# Japan Opinion about TF-BTA

JASIC

# Proposal regulation (GRSP-55-40 & 41)

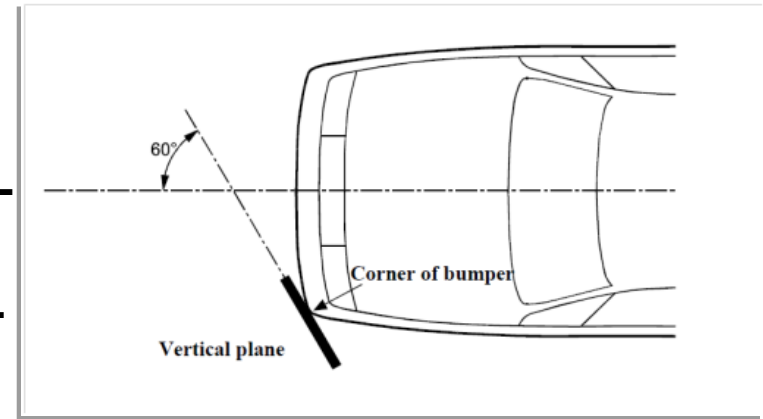
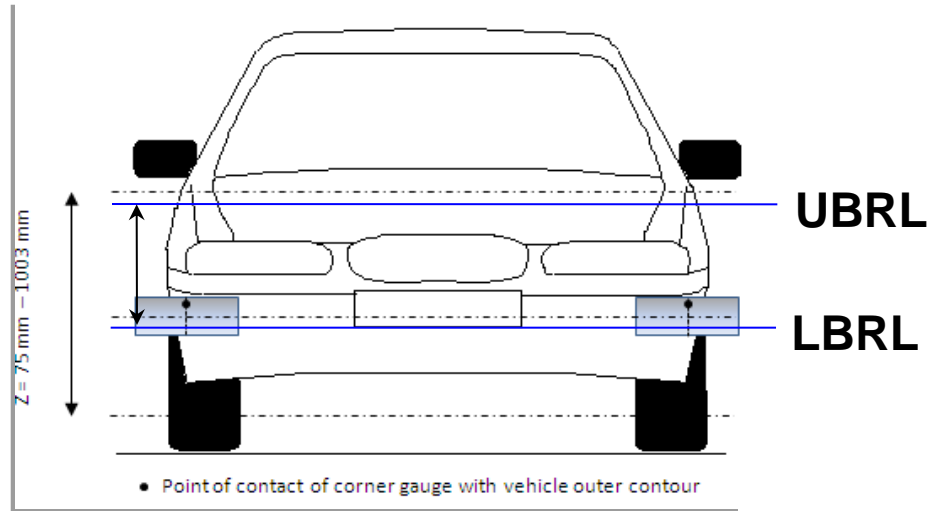
In Japan's opinion, both test methods are possible.

When the impactor is impacted with an angle, the impactor will spin, thus it is unclear if it will exhibit the same behavior as humans. Under the current regulation, an angle up to 60 degrees is allowed

The bumper beam proposal will be tested in the case the angle of impact point exceeds 60 degrees. In that case, whether or not the bumper beam exhibits the same behavior as humans is not guaranteed.

This may not result in improving the safety of pedestrians during actual accidents.

Therefore, Japan would like to [support proposal \(a\)](#).
